## APPLICATION FOR CERTIFICATE OF APPROPRIATENESS HISTORIC CONSERVATION BOARD PUBLIC HEARING STAFF REPORT

APPLICATION #: COA2018014/ZH20180042  
APPLICANT: Sanyog Rathod/Sol Design  
OWNER: Thomas Hadley and Pamela Luttmers  
ADDRESS: **519 Liberty Hill**  
PARCELS: 0075-00020112  
ZONING: Residential Multi-Family (RM 1.2)  
OVERLAYS: Prospect Hill Historic District/ Hillside District  
COMMUNITY: Mount Auburn  
REPORT DATE: March 26, 2018, April 16, 2018  
STAFF REVIEW: Beth Johnson, Urban Conservator

APPLICATION #: COA2018020  
APPLICANT: Jeckering Schneider Architects  
OWNER: OMS Properties Management  
ADDRESS: **1636 Chase Avenue**  
PARCELS: 196-0026-0054  
ZONING: CC-P  
OVERLAYS: Northside NBD Historic District  
COMMUNITY: Northside  
REPORT DATE: April 5, 2018  
HEARING DATE: April 23, 2018  
STAFF REVIEW: Douglas Owen, Zoning Plan Examiner

RENDERING OF PROPOSED AWNING  
NTS (A)

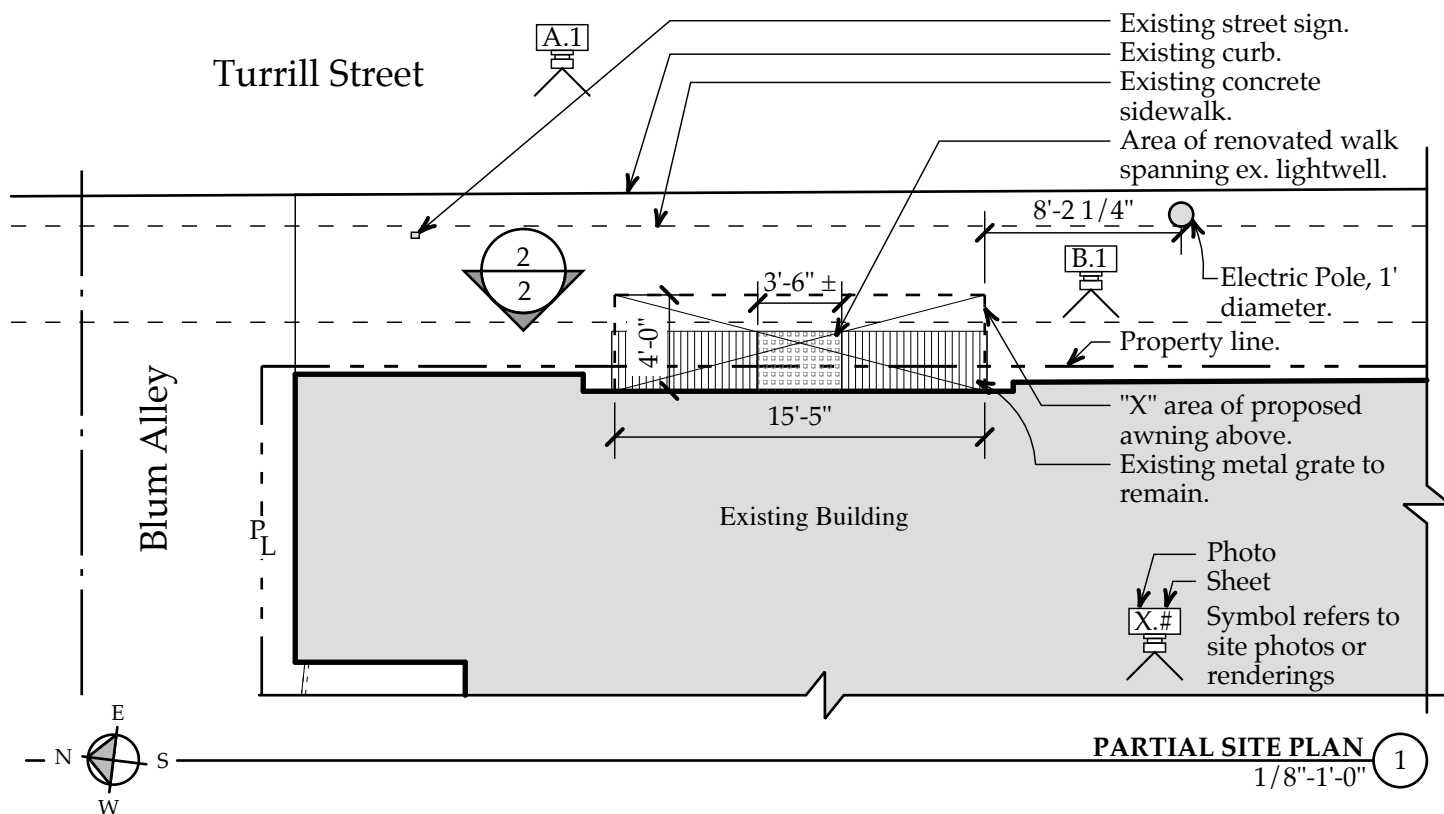
The proposed canopy will consist of a metal frame that will be similar to the metal header beam above the garage door opening on the Chase Avenue frontage. Metal rods attached to the brick façade will support the frame. Tempered glass panels will cover the opening of the awning. Plans call for a corrugated metal as an alternate material. The glass is appropriate as it will allow a visual through the canopy. Corrugated metal is not appropriate.

A. **APPROVE** a Certificate of Appropriateness for 1636 Chase Avenue per plans by Jeckering Schneider Architects and dated 12.08.2018 including any revisions submitted for permit subject to staff review and approval with the following condition:

**ARCHITECTURAL SITE PLAN**  
1/8" = 1'-0"

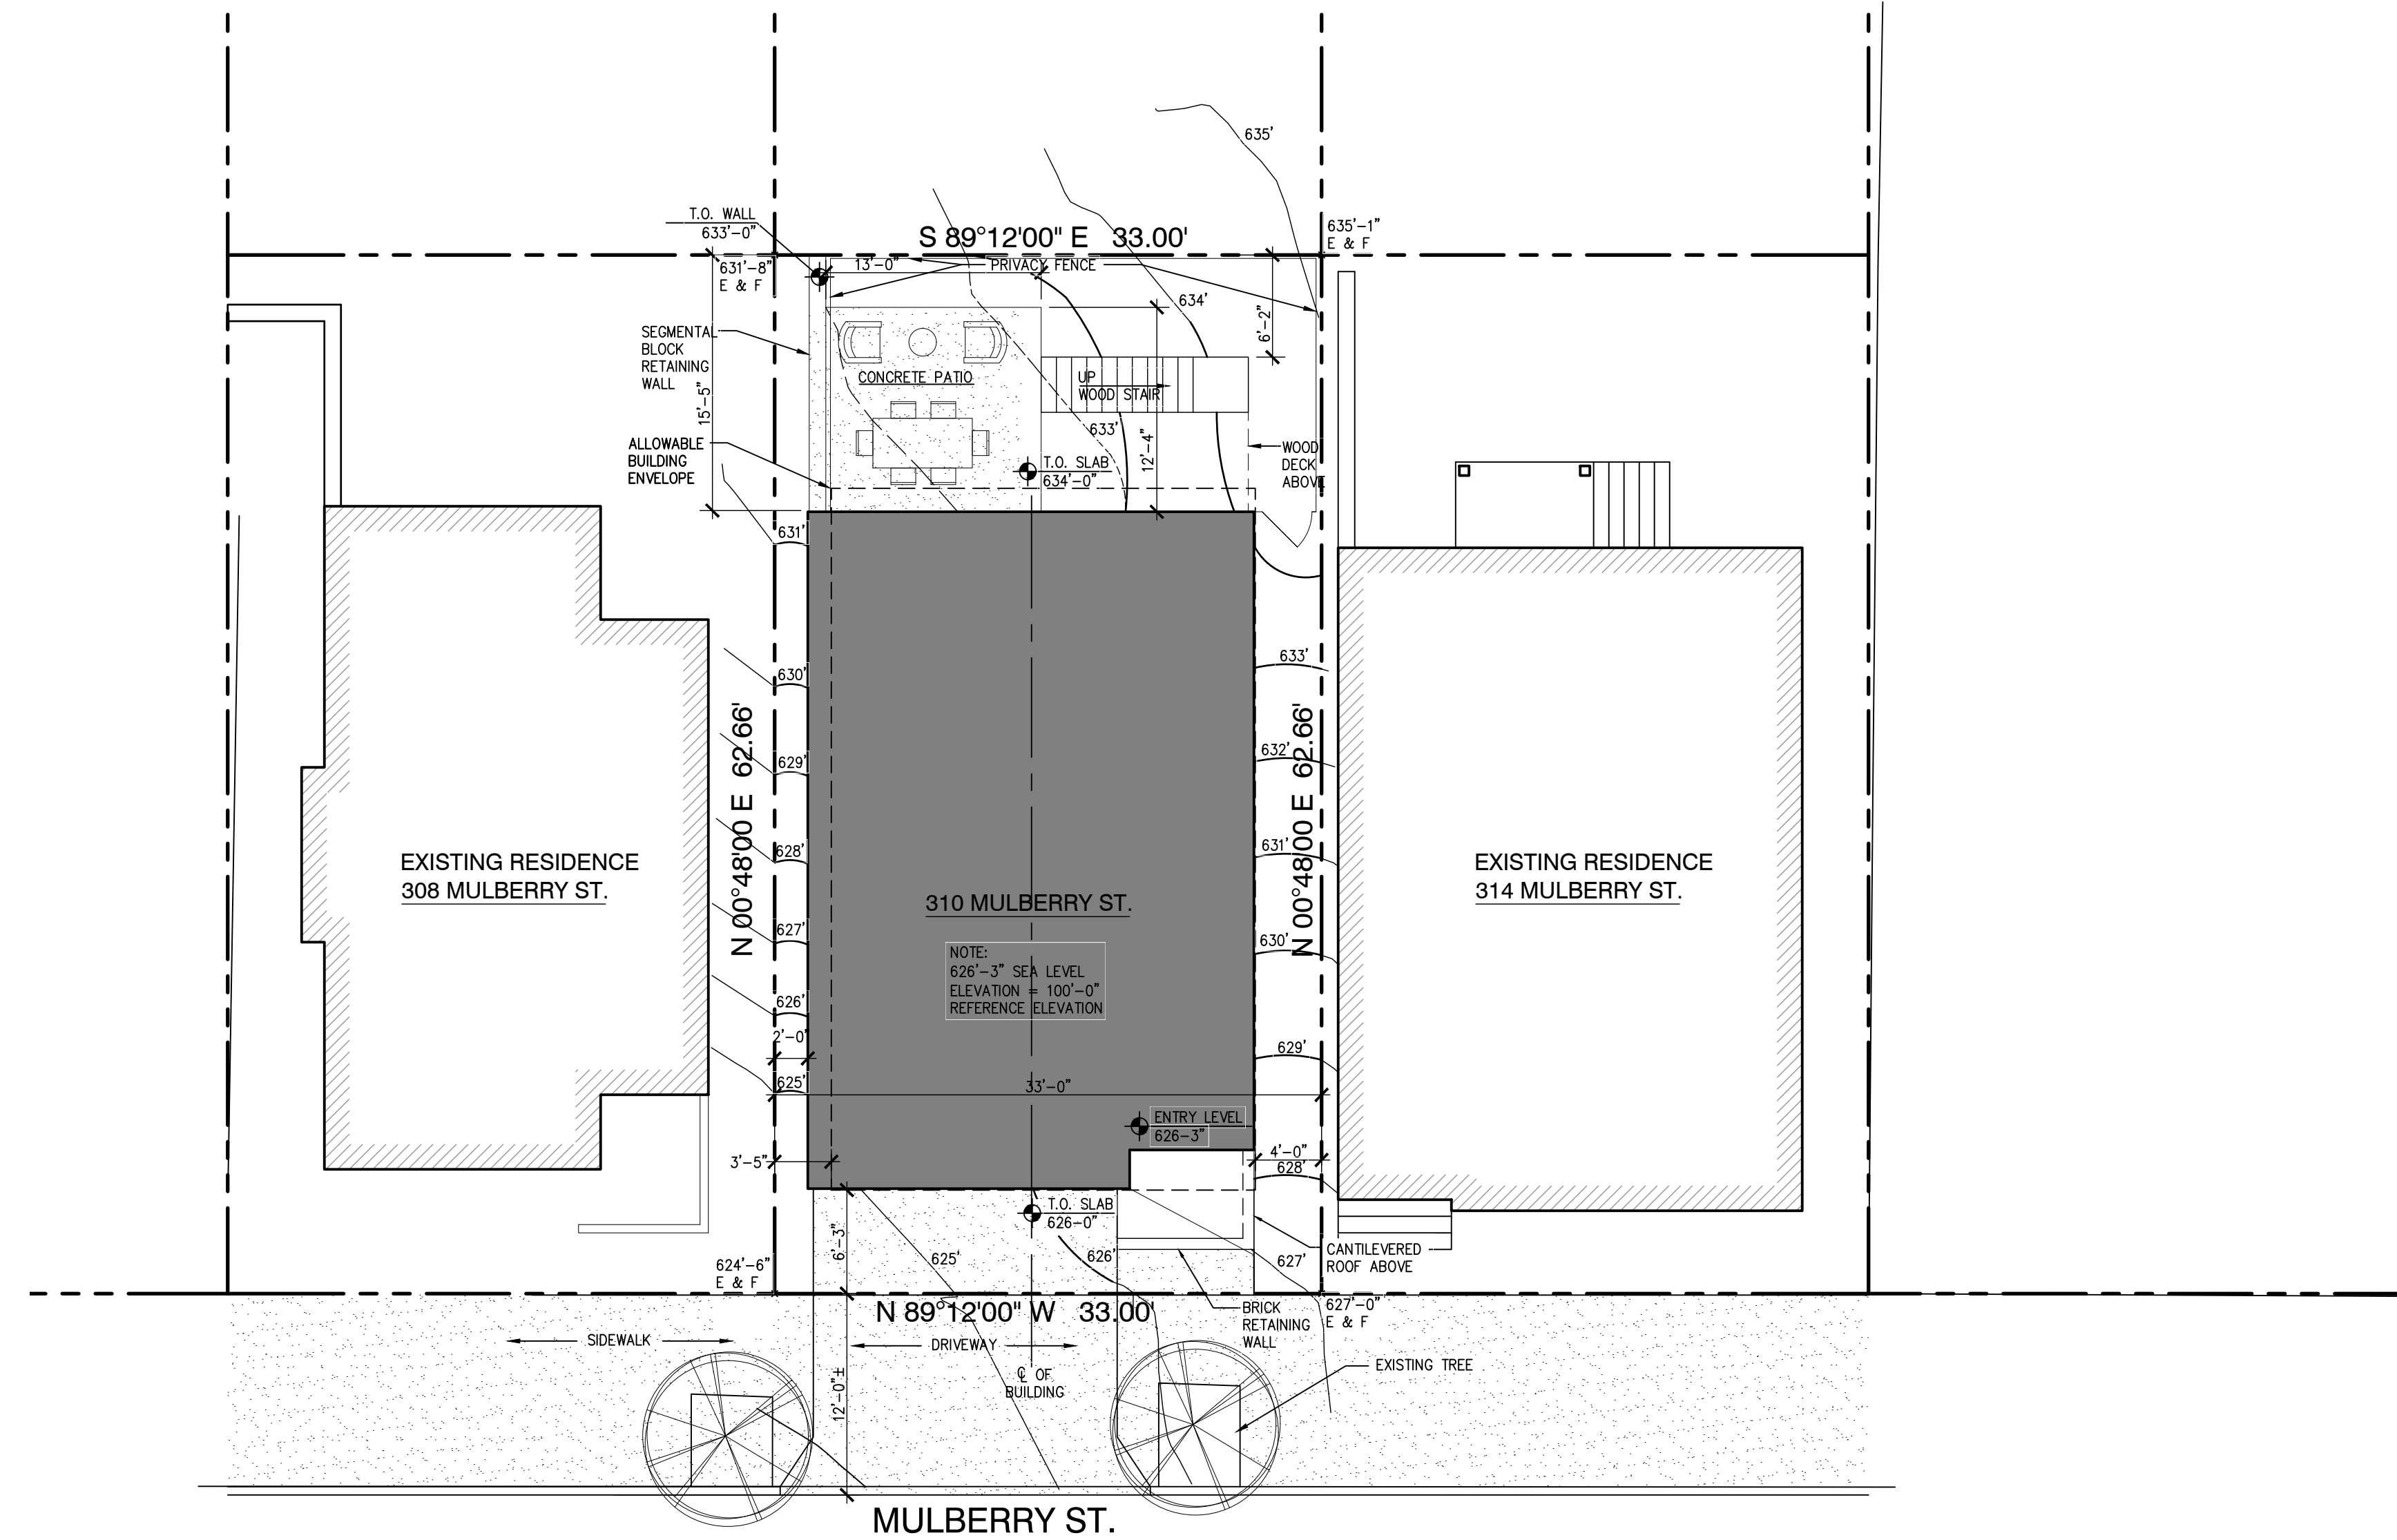
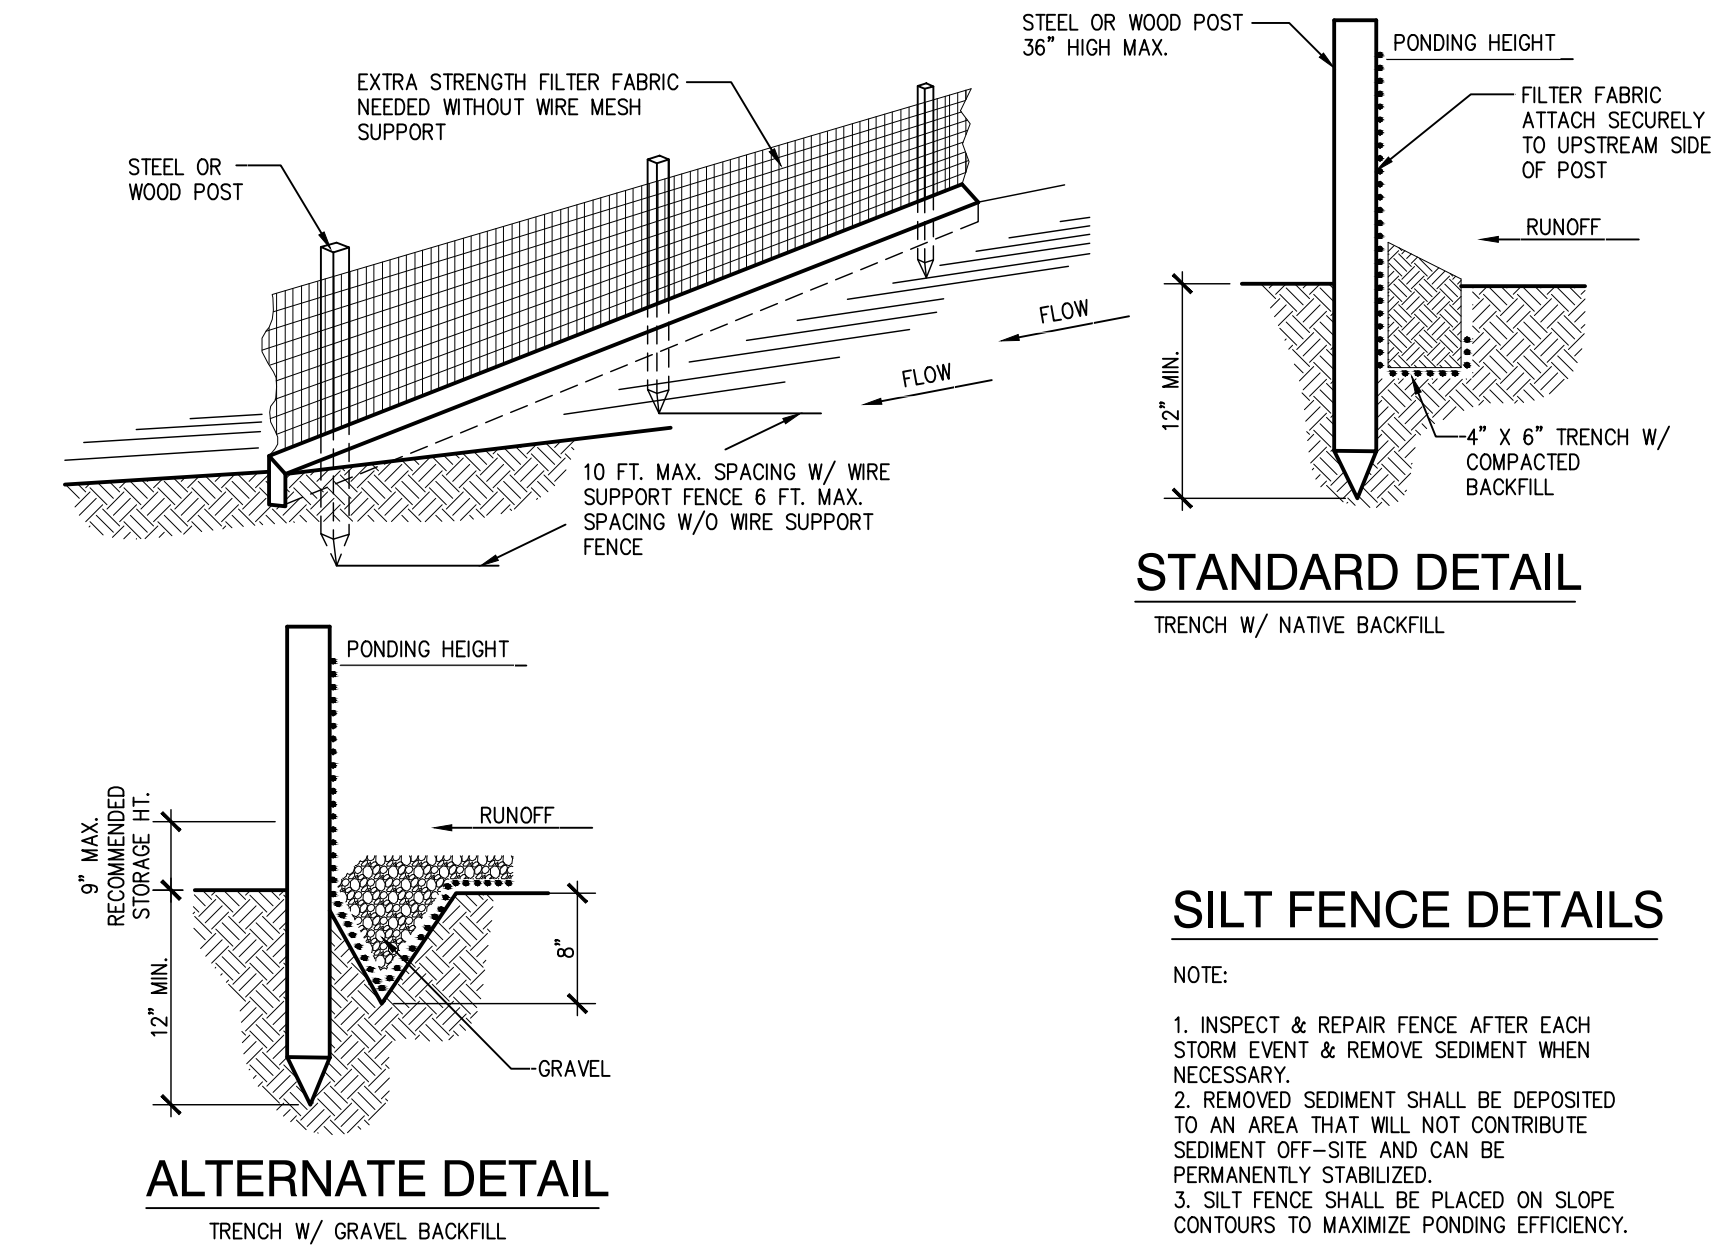
1405.07 Front Yard Setback. Refer to attached drawing sheet A1.1. The neighboring building at 308 Mulberry is setback 7'-6" and the neighboring building at 314 is setback 5'-0". By using averaging it establishes a 6'-3" setback at the proposed residence. We are requesting a variance of 4'-0" for a minimal roof covering, this reduces the setback to 2'-3". By granting this relief we are able to provide adequate cover at the Entry door, without adversely reducing the designed footprint of the building.

1405.07 Rear Yard Setback. Refer to attached drawing sheet A1.1. The neighboring building at 308 Mulberry is setback 15'-2" and the neighboring building at 314 Mulberry is setback 12'-6". By using averaging it establishes a 14'-4" setback at the proposed residence. We are requesting a variance of 8'-2" and reduce the setback to 6'-2". This will allow for a small deck on the living level and a stair to access the rear patio on grade, very similar to the deck and stair at 306 Mulberry St. By granting this relief the 41'-0" deep home can be constructed on the site with out adversely reducing the designed footprint of the building.
